HISTORIC AND DESIGN REVIEW COMMISSION

HDRC CASE NO: 2024-110
ADDRESS: 134 E MULBERRY AVE
LEGAL DESCRIPTION: NCB 1702 BLK 6 LOT 9, W25 FT OF 10
ZONING: R-4, H
CITY COUNCIL DIST.: 1
DISTRICT: Monte Vista Historic District
APPLICANT: Alberto encinia/a. e. secure investments corp
OWNER: Charles Gonzales/GONZALEZ LINDA LOPEZ & CHARLES
TYPE OF WORK: New construction of a rear accessory structure
APPLICATION RECEIVED: March 27, 2024
60-DAY REVIEW: April 29, 2024
CASE MANAGER: Rachel Rettaliata

The applicant is requesting a Certificate of Appropriateness for approval to construct a 1-story, 655-square-foot rear accessory structure.

2 ROOF PLAN
SCALE: 1/4" = 1'-0"

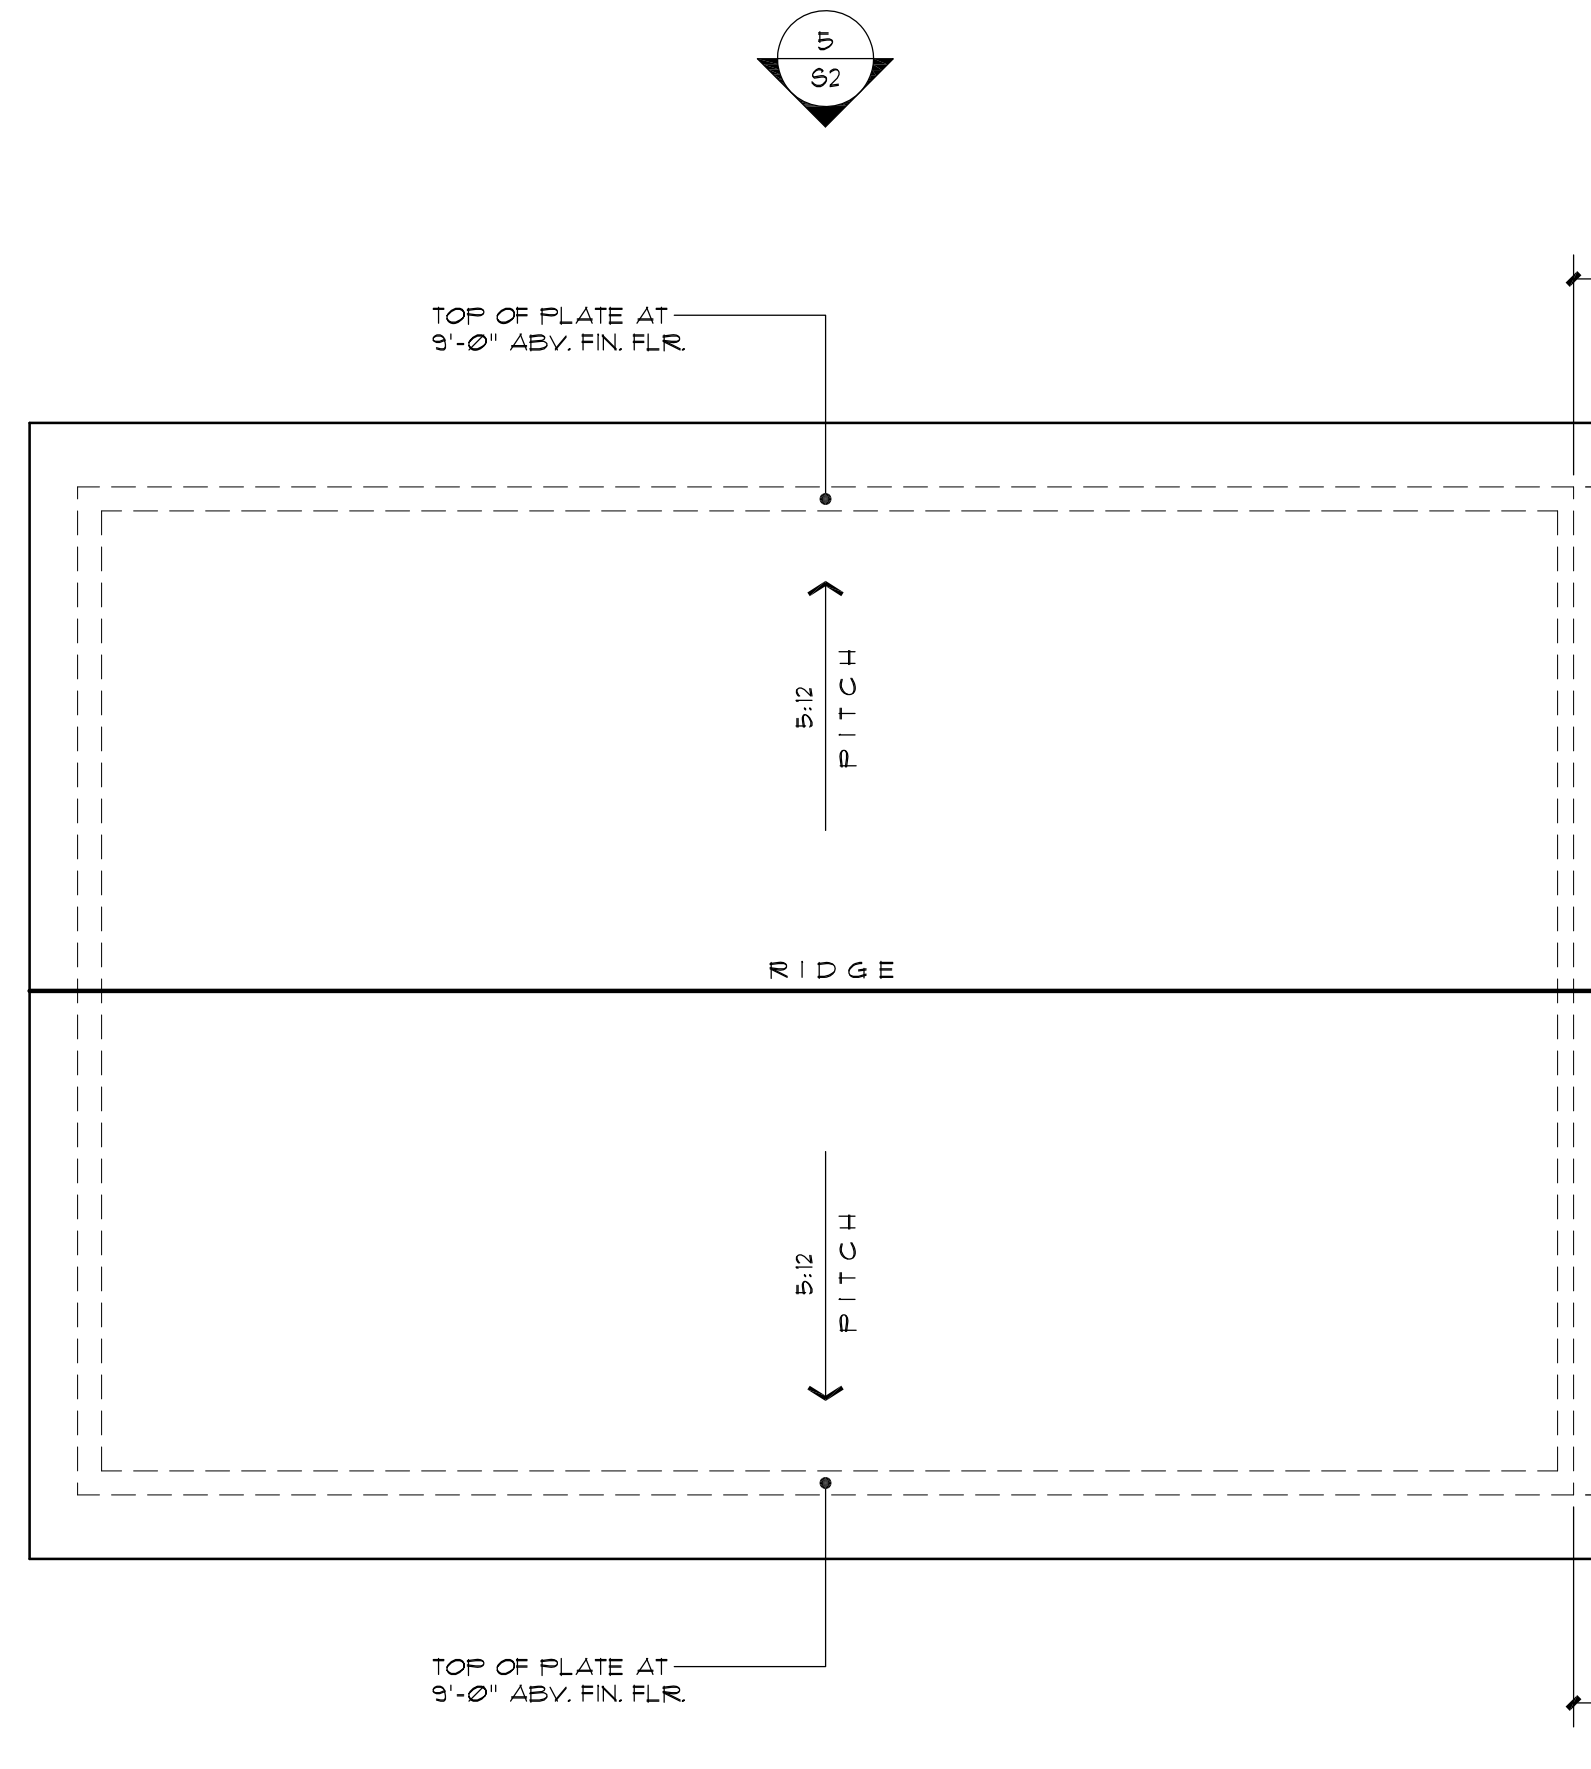
- g. **ROOF FORM** – The applicant has proposed a side gable roof form on the new rear accessory structure. Guideline 2.B.i for New Construction states that new construction should incorporate roof forms – pitch, overhangs, and orientation – that are consistent with those predominantly found on the block. The roof form on the primary structure is a side gable roof with a steeply pitched front gable over the entryway. Staff finds the form consistent with the Guidelines.

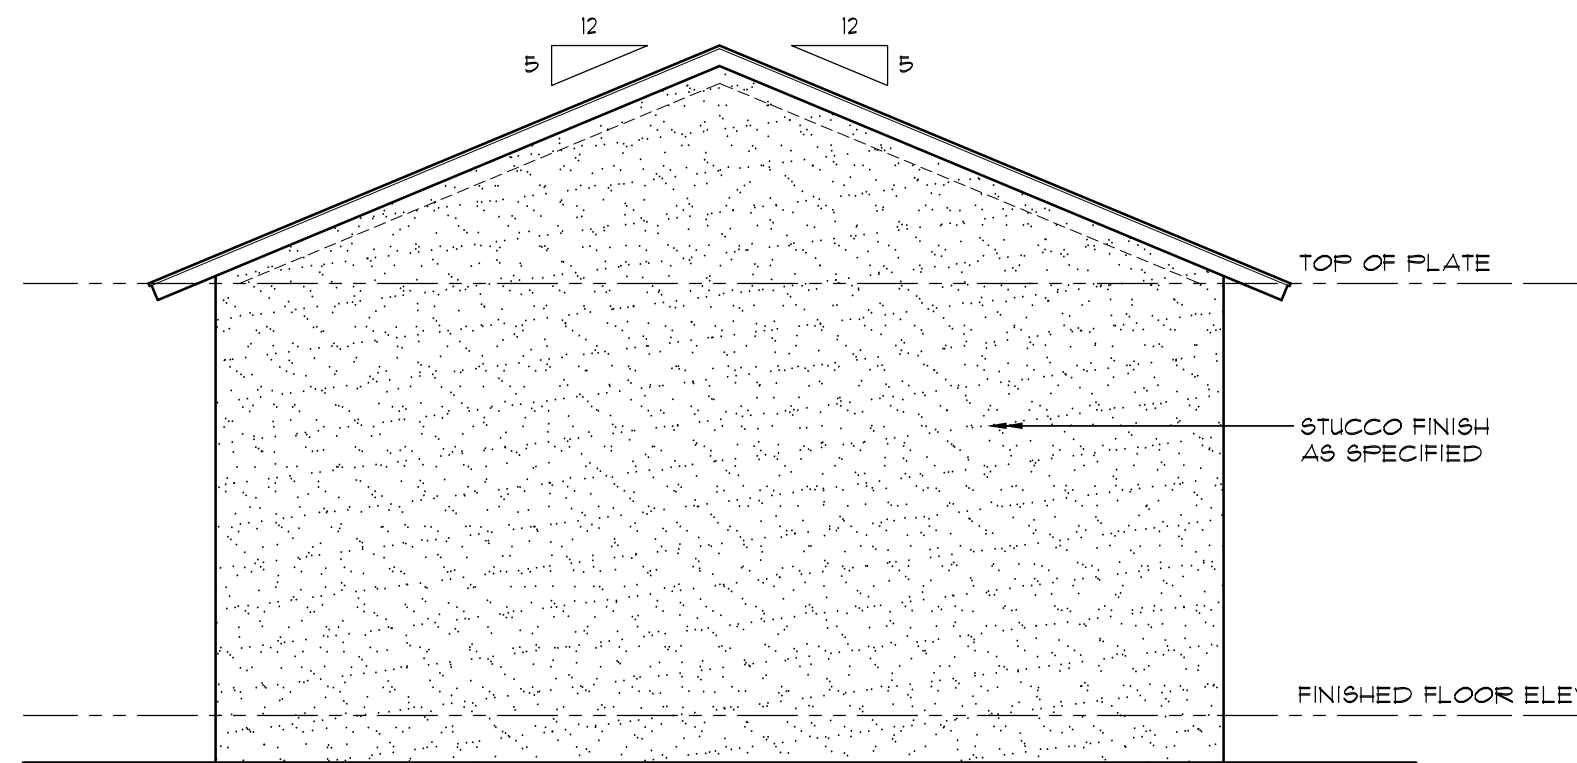
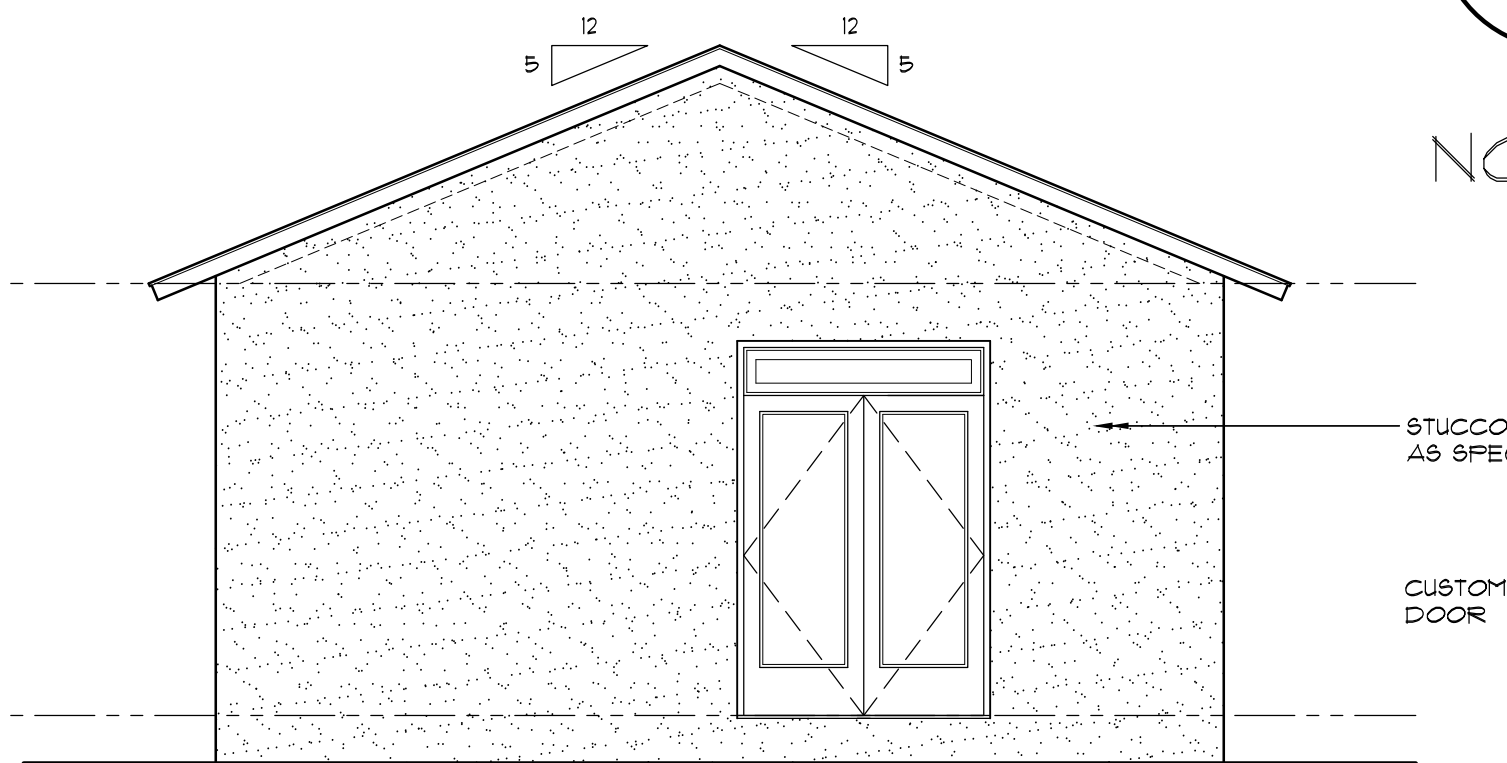
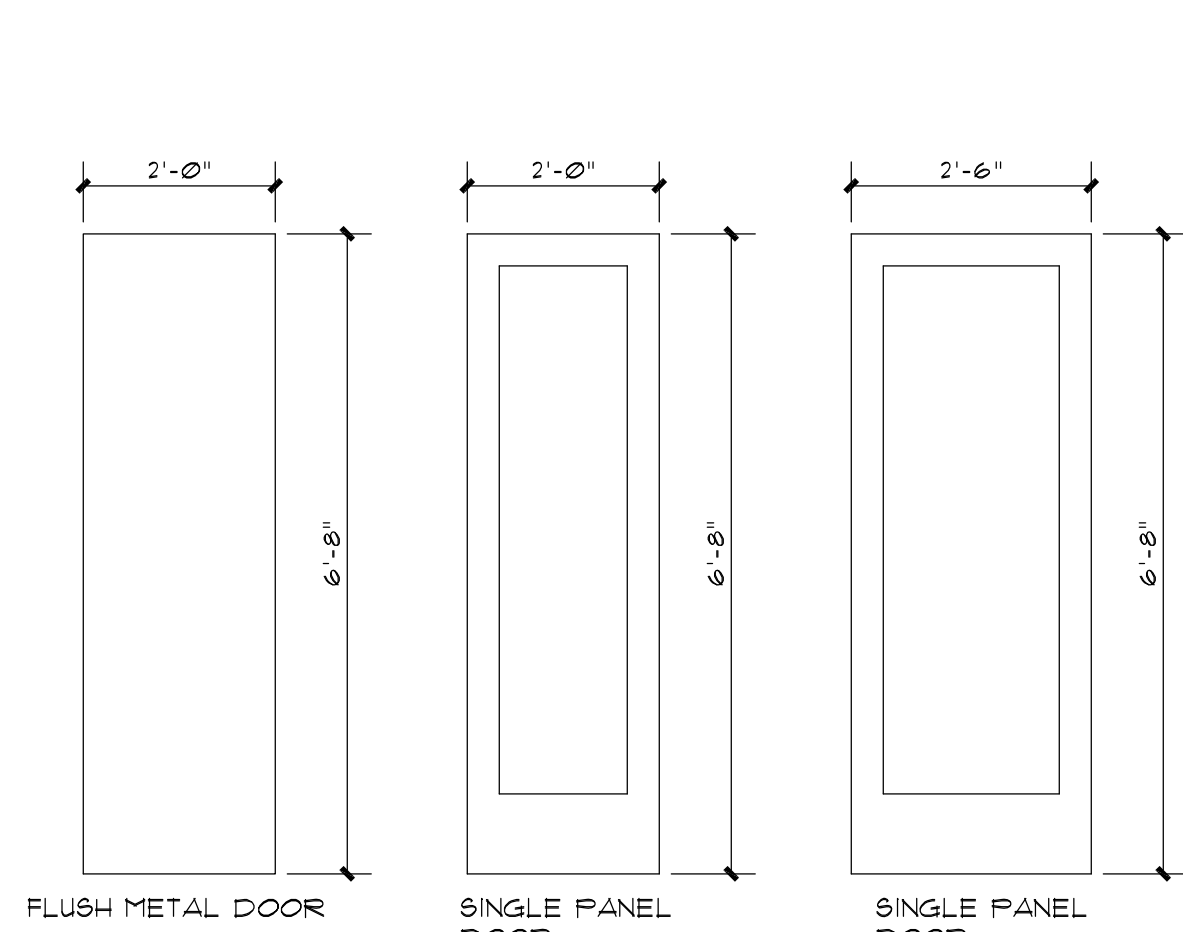
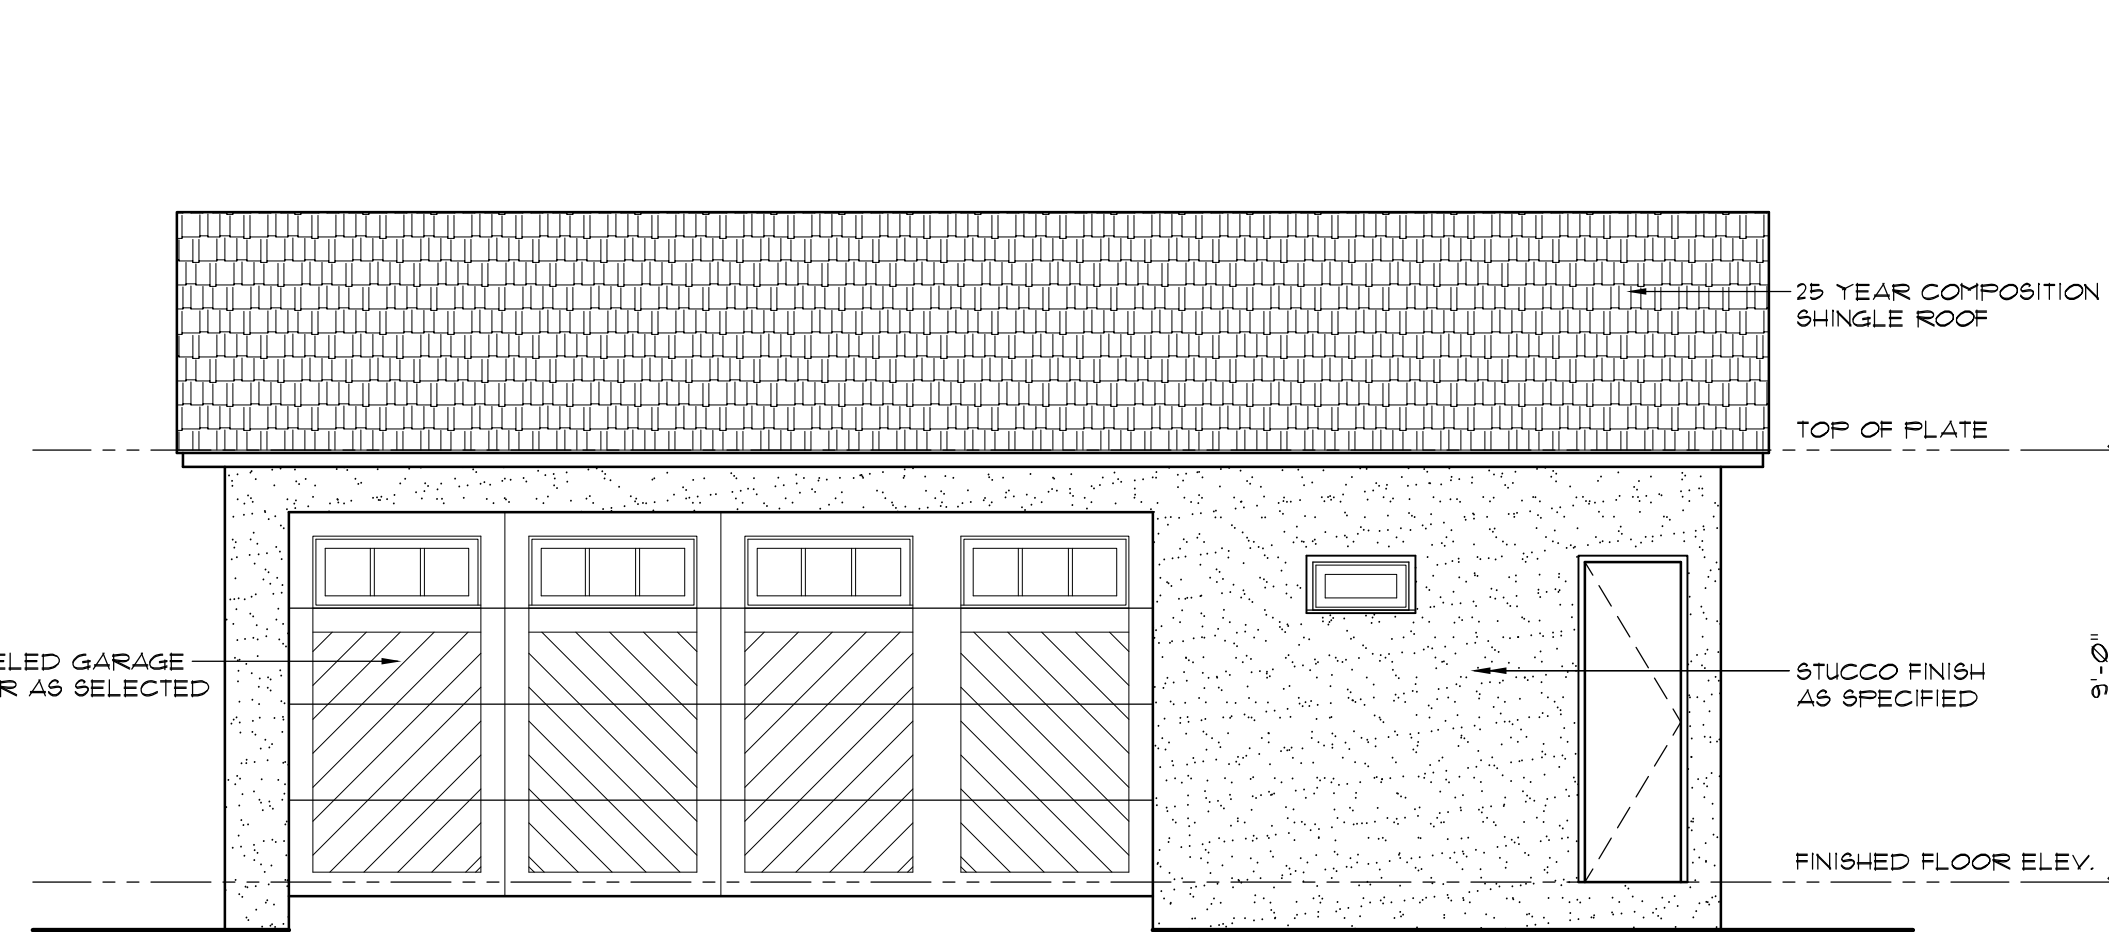
- h. **RELATIONSHIP OF SOLIDS TO VOIDS** – Per the Guidelines for New Construction 2.C.i., window and door openings with similar proportions of wall to window space as typical with nearby historic facades should be incorporated into new construction. The applicant has proposed to install one carriage-style garage door, and two entry doors with divide lites on the north façade facing the public right-of-way, two sets of garage doors, a solid metal door, and a narrow fixed window on the south elevation facing the alley, a set of full lite French doors with a transom window on the east elevation facing the rear yard, and no fenestration on the west elevation facing the neighboring property. Staff finds that proposed fenestration pattern is generally appropriate and that the proposed window on the rear alley-facing elevation is appropriate for the context of the structure.

- i. **MATERIALS** – The Guideline 5.A.iii for New Construction states that new outbuildings should relate to the period of construction of the principal building on the lot through the use of complementary materials and simplified architectural details. The applicant has proposed to install a composition shingle roof and stucco cladding to match the primary structure. Staff finds that the pedestrian doors should be made of wood or be wood-look doors, garage doors should be wood or wood-look, and that the proposed window should be fully wood or aluminum-clad wood and feature an inset of two (2) inches within façade. White manufacturer’s color is not allowed, and color selection must be presented to staff. There should be a minimum of two inches in depth between the front face of the window trim and the front face of the window. This must be accomplished by recessing the window sufficiently within the opening or with the installation of additional window trim to add thickness. Window trim must feature traditional dimensions and architecturally appropriate sill detail. An alternative window material may be proposed, provided that the window meets the remaining specifications.

- j. **ARCHITECTURAL DETAILS** – New buildings should be designed to reflect their time while representing the historic context of the district. Additionally, architectural details should be complementary in nature and should not detract from nearby historic structures. Staff finds the architectural details to be generally appropriate.

- i. That the applicant submits final material specifications for the proposed window to staff for review and approval prior to the issuance of a Certificate of Appropriateness based on finding i. The window must be fully wood or aluminum-clad wood and meet staff’s standard window stipulations. The windows should feature an inset of two (2) inches within facades and should feature profiles that are found historically within the immediate vicinity. White manufacturer’s color is not allowed, and color selection must be presented to staff. There should be a minimum of two inches in depth between the front face of the window trim and the front face of the window. This must be accomplished by recessing the window sufficiently within the opening or with the installation of

additional window trim to add thickness. Window trim must feature traditional dimensions and architecturally appropriate sill detail. An alternative window material may be proposed, provided that it meets the remaining specifications.

- ii. That the applicant submits final material specifications for wood or wood-look pedestrian doors and fully wood or wood-look garage doors to staff for review and approval prior to the issuance of a Certificate of Appropriateness based on finding i.
- iii. That the applicant meets all setback standards as required by city zoning and obtain a variance from the Board of Adjustment if applicable.
